La Jolla Shores Planned District Advisory Board (LJSPDAB)
APPLICANT PROJECT INFORMATION FORM

- Project Tracking System (PTS) Number/Accela "PRJ" Number and Project Name (only submitted projects to the Development Services Department can be heard as action items):
PRJ 1120759

Site Development Plans PRJ-1120759.pdf

SITE PLAN

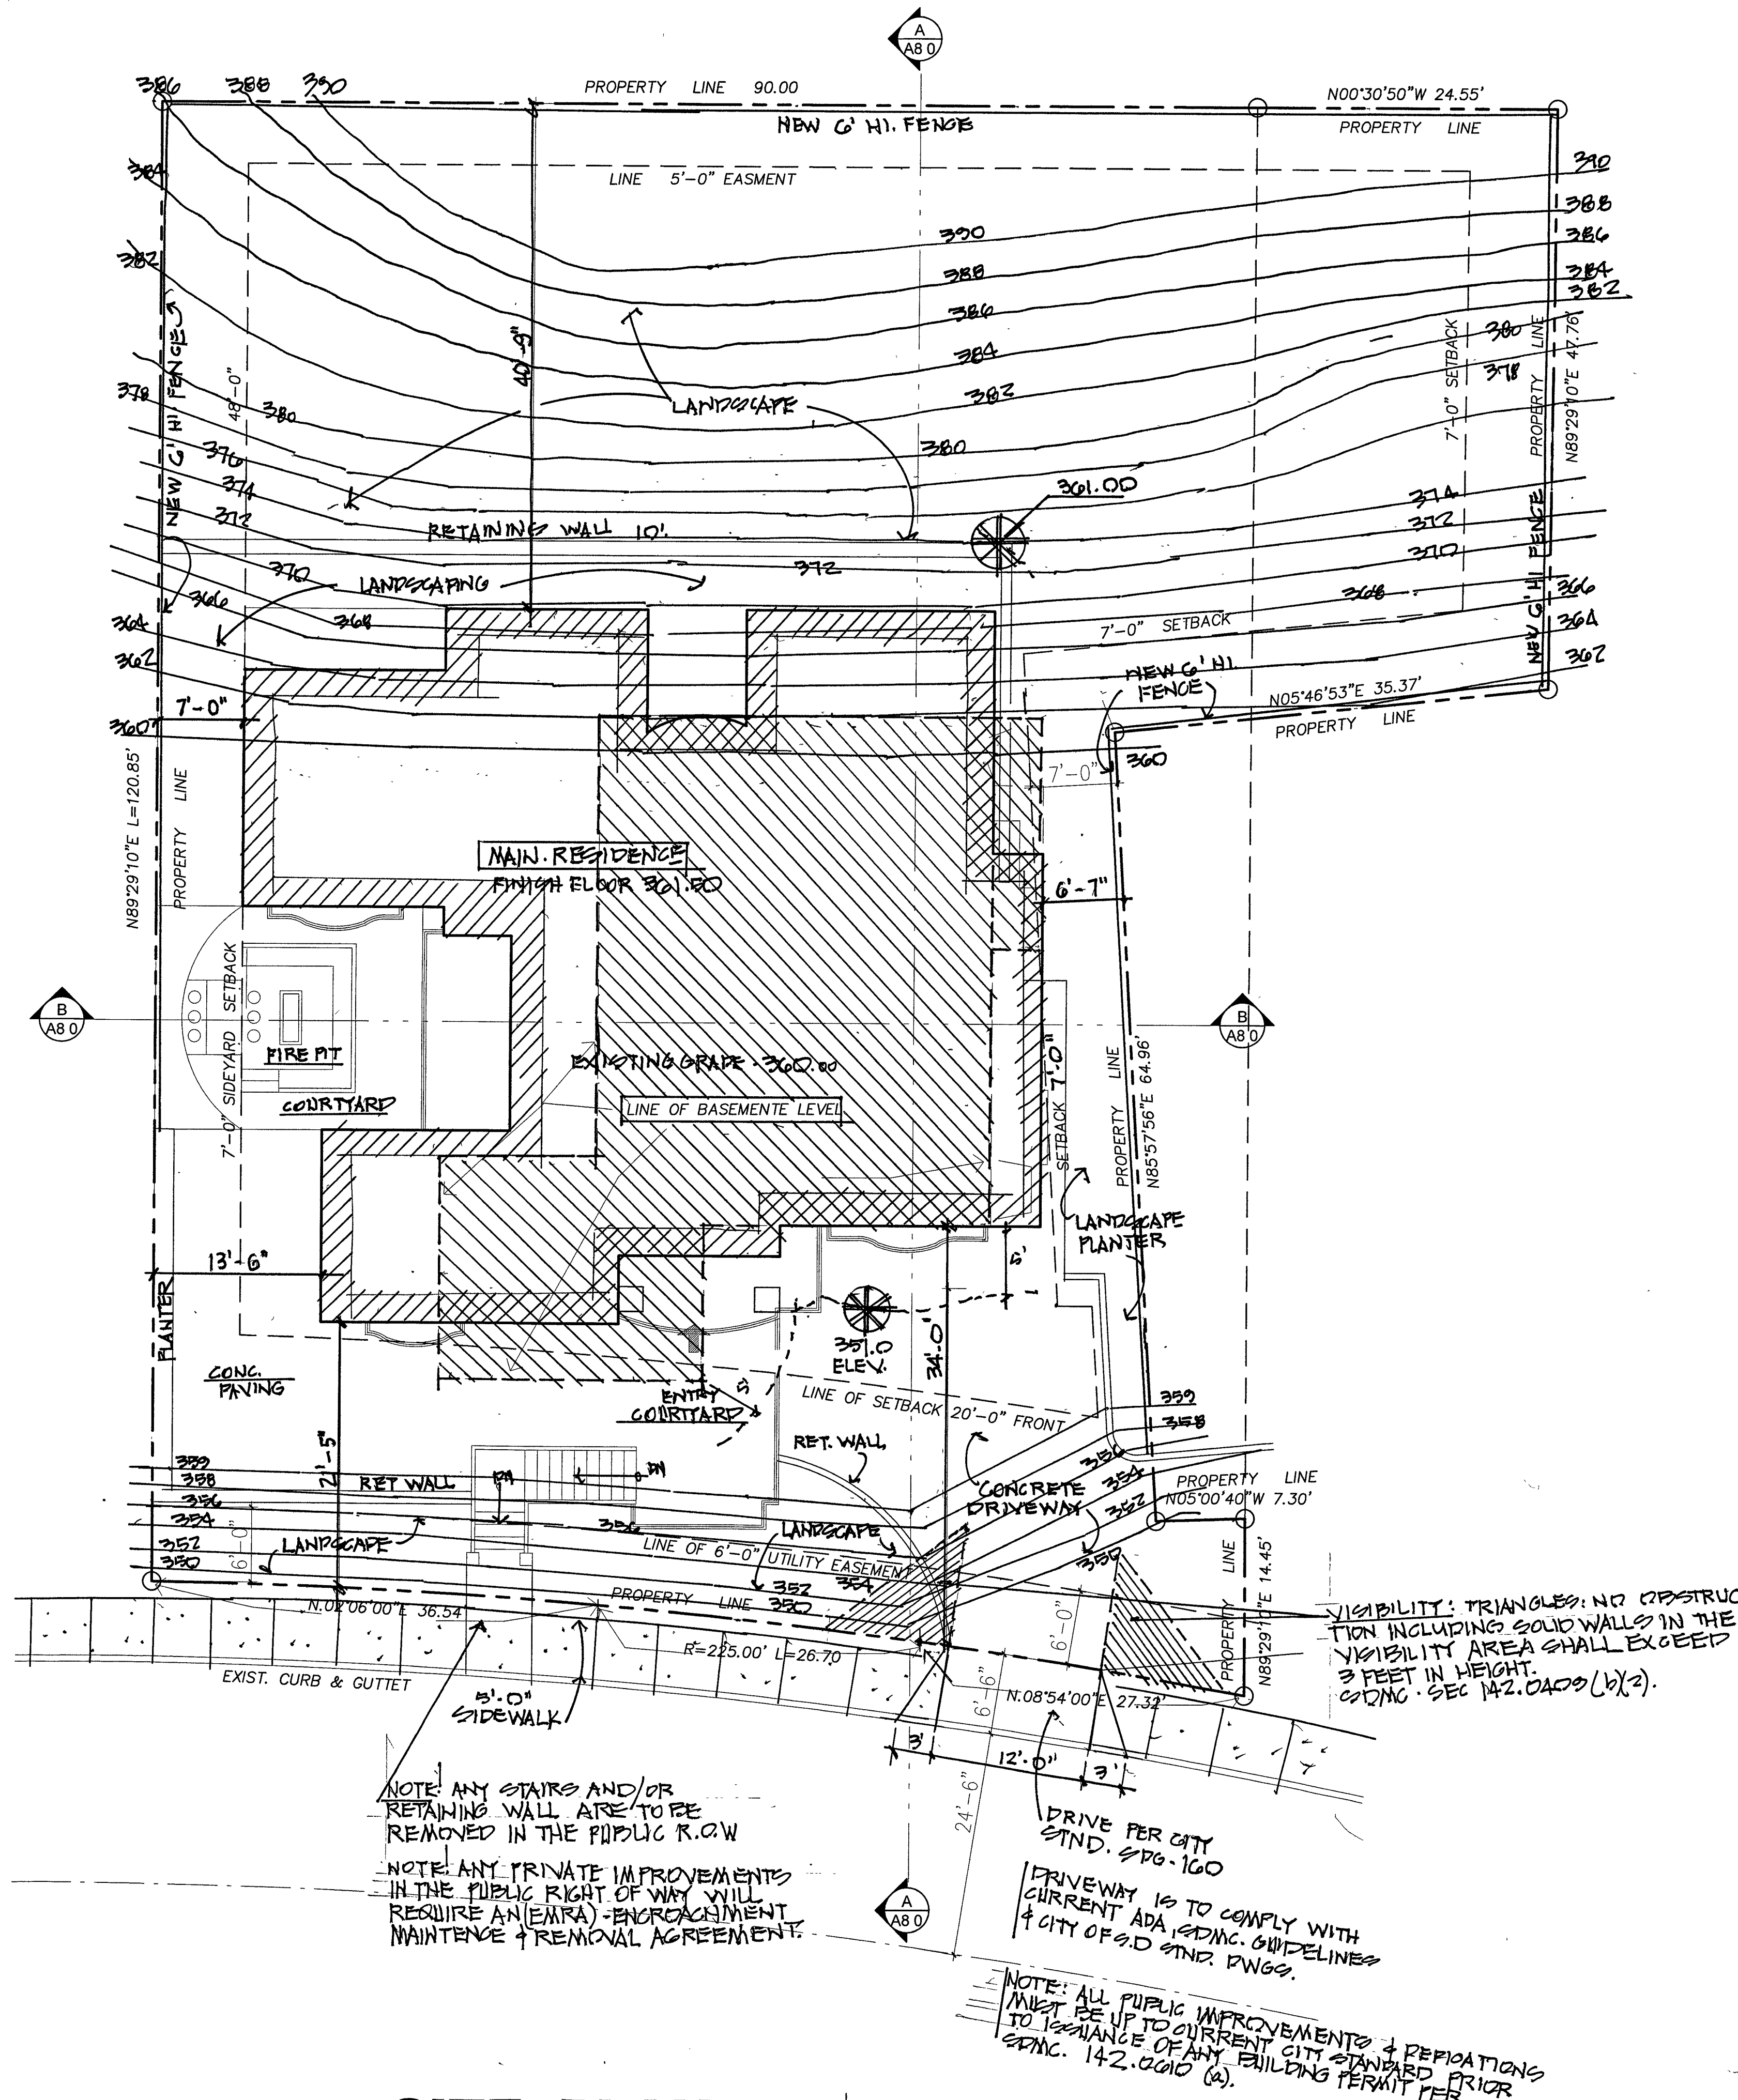
ALO ☐ In accordance with subdivision map 4382, the property has a previously established front setback of 20' abutting Sugarman Drive, and a 4' utility easement running along the rear property line, and in accordance with parcel map 21806, there's a 6' easement in favor of SDG&E located at the front of the property, and a ROW easement running along the southerly property line. Please update site plan upon resubmittal and clarify if easements are vacated.

OK ☐ On the site plan, the proposed SDU, is shown as encroaching into the front yard setback, please note that the premises is subject to the previously established front setback of 20' per the subdivision map 4382, and the structure would not be allowed to encroach. Please redesign.

On the site plan, please show, label, and dimension the contours of the lot. Five- and ten-foot contour intervals may be acceptable provided spot elevations are called out as necessary for the analyst to properly understand the character of the site. Show contours off-site within 50 feet of the property line.

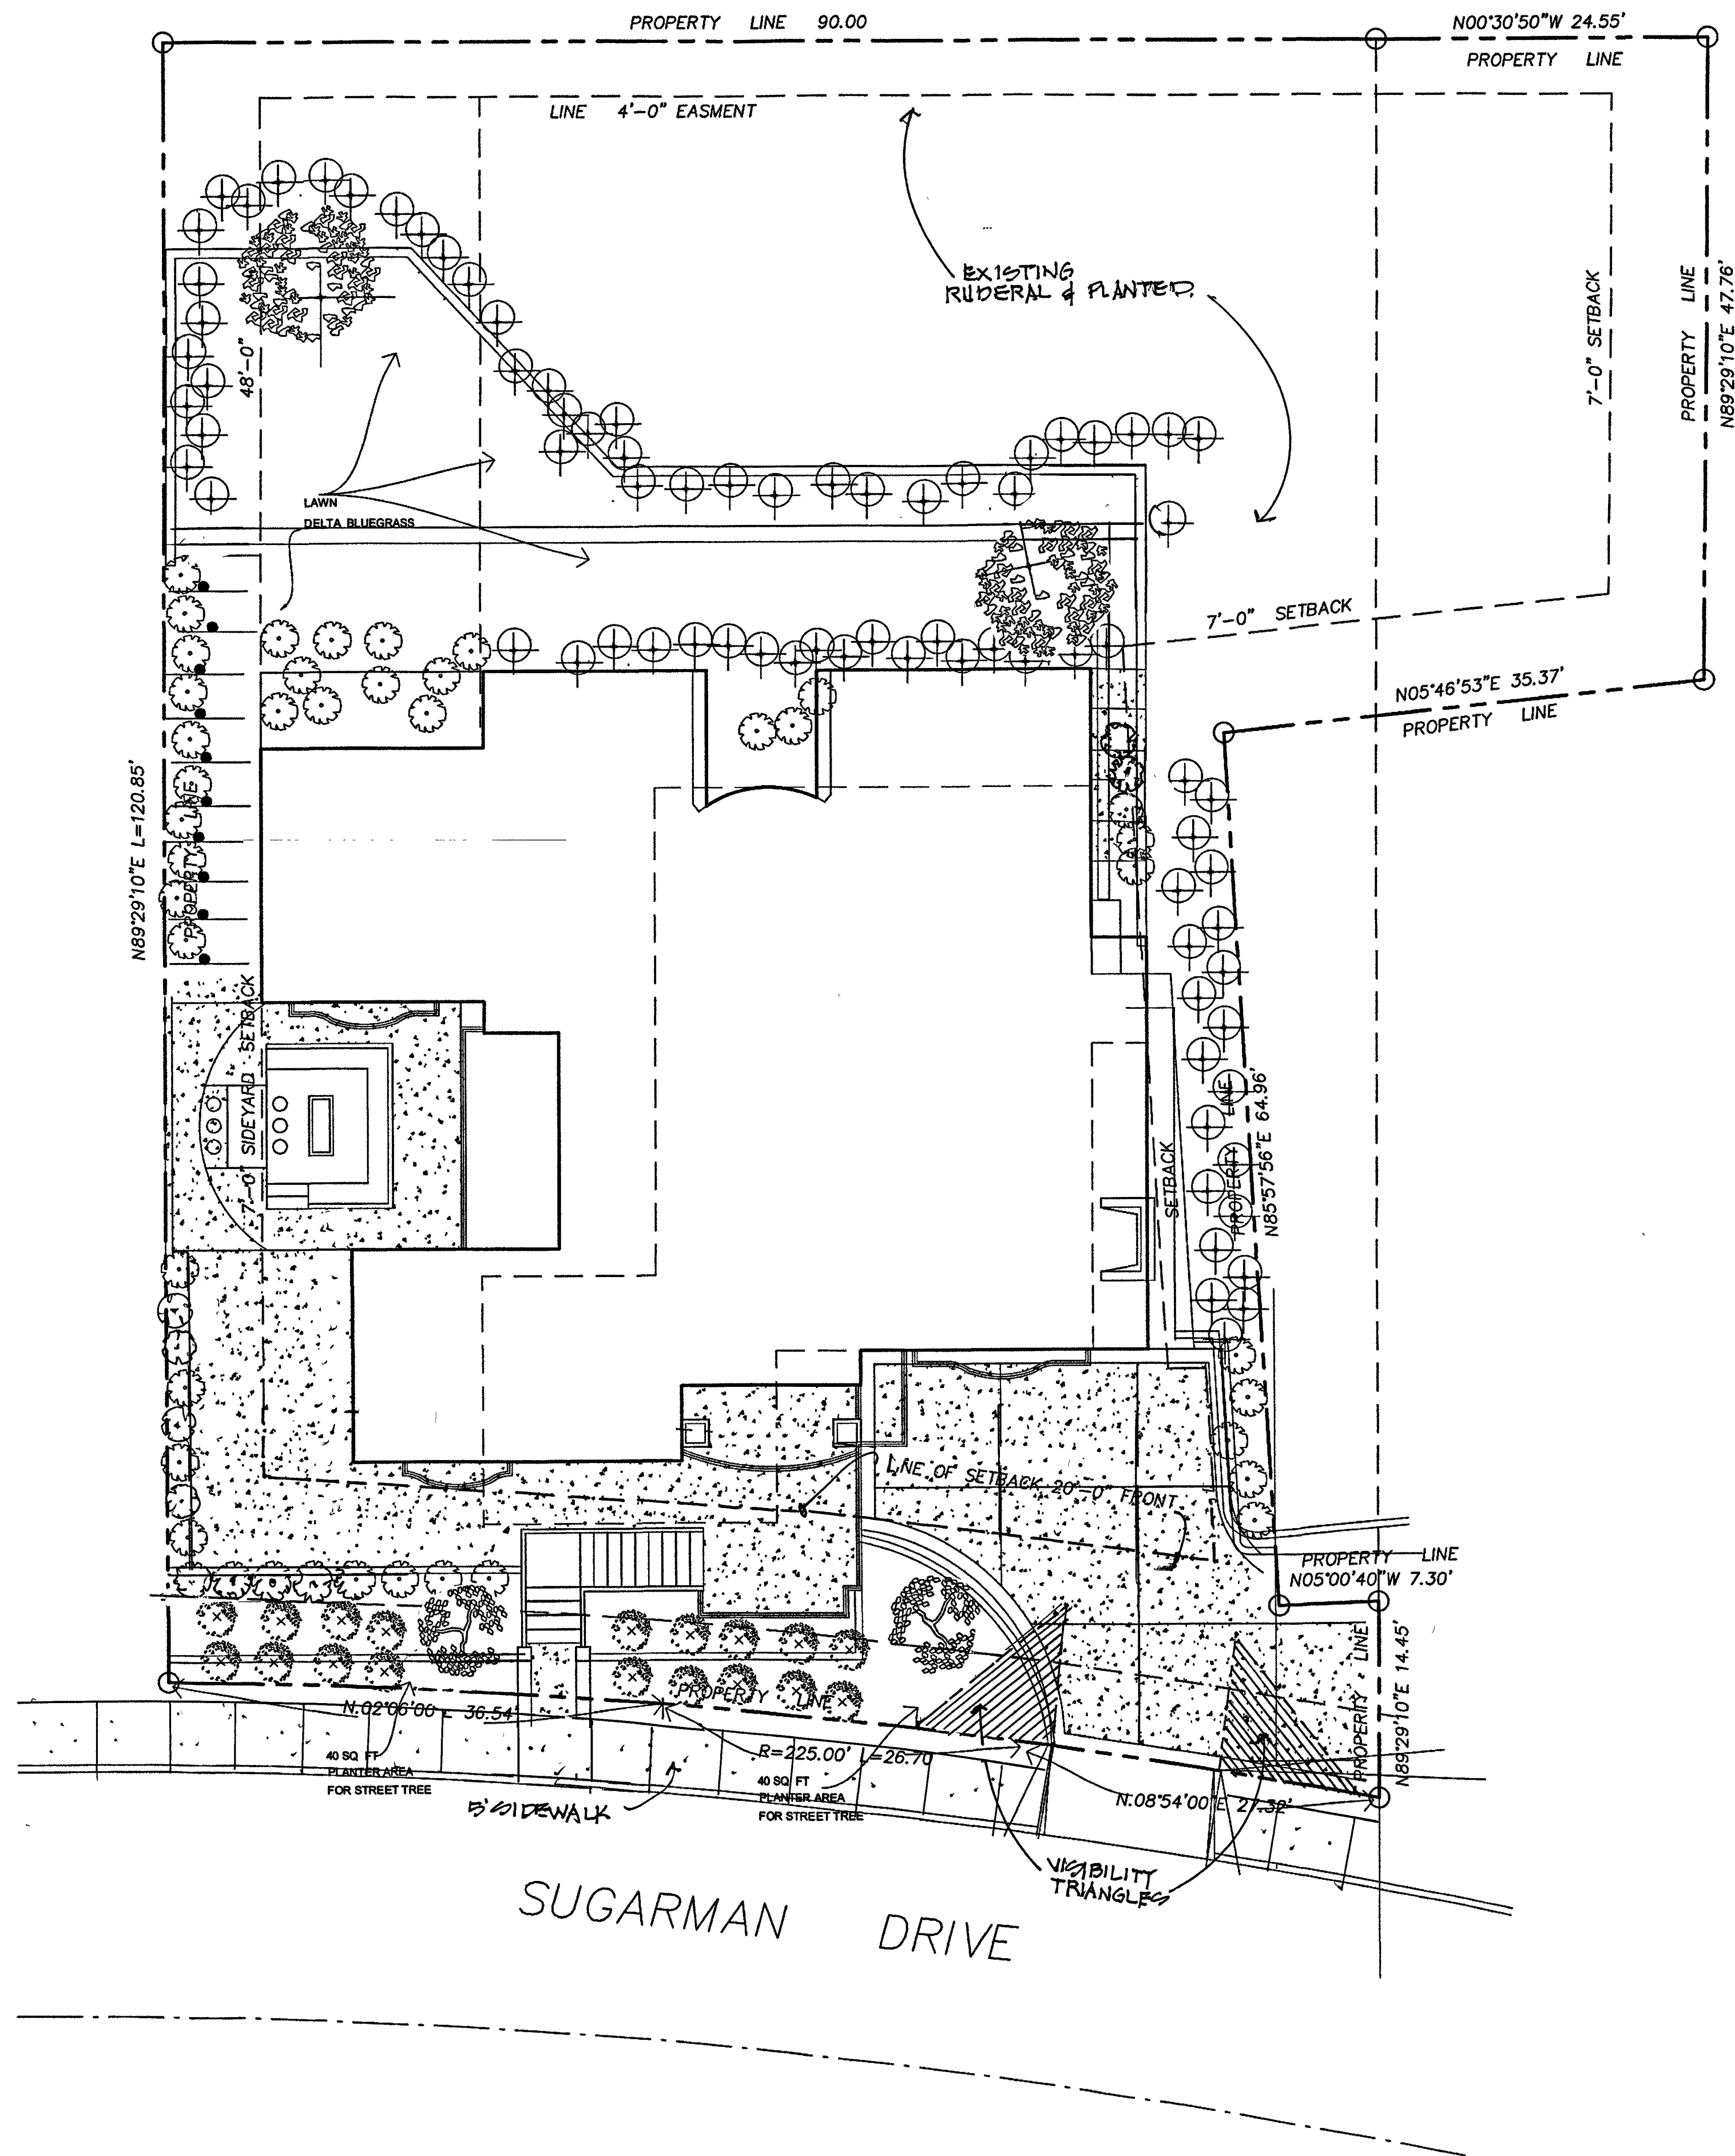
Required Street Trees: This project is subject to two street trees per SDMC 142.0409. Please provide two street trees per PTS625569 five feet from and outside the utility easement.

A9.0 Utility Easement: Please label the 6 foot utility easement from sheet A1 on all landscape sheets.

A9.0 Sidewalk: Show public sidewalk on all site plans.

Visibility Triangles: Please show all visibility triangles on landscape plans.

Per SDMC Section 142.0409 (b)(2), Plant material, other than trees, located within visibility areas or the adjacent public right-of-way shall not exceed 36 inches in height, measured from the lowest grade abutting the plant material to the top of the plant material.
